Amendments to the Drawings

Drawings

Fig. 1-4"

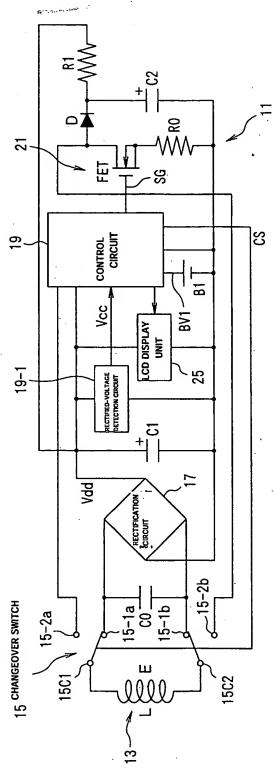
The Action objects to the drawings under 37 CFR 1.83(a) and asserts that they fail to show the booster circuit recited in the claims and described in the specification.

Nevertheless, in order to clarify matters, the application is amended to include new Figs. 1B and 4B. Figs. 1B and 4B are the same as Figs. 1 and 4, with the exception that contacts 15c1 and 15c2 are connected to second connection terminals 15-2a and 15-2b, rather than first connection terminals 15-1a and 15-1b, as in Figs. 1 and 4. Thus, new Figs. 1B and 4B explicitly illustrate the connected

As is clearly described in applicant's specification (see paragraphs [0019]-[0022] and [0029]-[0031], for example), the contactless-tag electronic circuit 11 of Fig. 1 (and Fig. 4) includes a changeover switch 15 that switches circuit 11 between two states: a resonance circuit-formed state including an antenna coil L and a rectification circuit 17, which is formed when contacts 15c1 and 15c2 of antenna coil L connect to a first set of connection terminals 15-1a and 15-1b; and a booster circuit-formed state including antenna coil L and a charge pump 21 including a transistor FET, which is formed when contacts 15c1 and 15c2 of antenna coil L changeover to a second set of connection terminals 15-2a and 15-2b.

Thus the booster circuit is a state of the circuit of Fig. 1 (and Fig. 4) wherein antenna coil contact terminals 15c1 and 15c2 connect to the second set of connection terminals 15-2a and 15-2b to couple charge pump 21 to antenna coil L. All of these elements are clearly shown in Fig. 1, so applicant respectfully traverses the objection that the booster circuit is not shown in the drawings.

state where circuit 11 includes the booster circuit. No new matter is added, since new Figs. 1B and 4B merely illustrate that which is described in multiple locations in the specification. For consistency with the new Figures, Figs. 1 and 4 are redesignated as Figs. 1A and 4A, and the specification is amended as necessary to make reference to the new Figures.
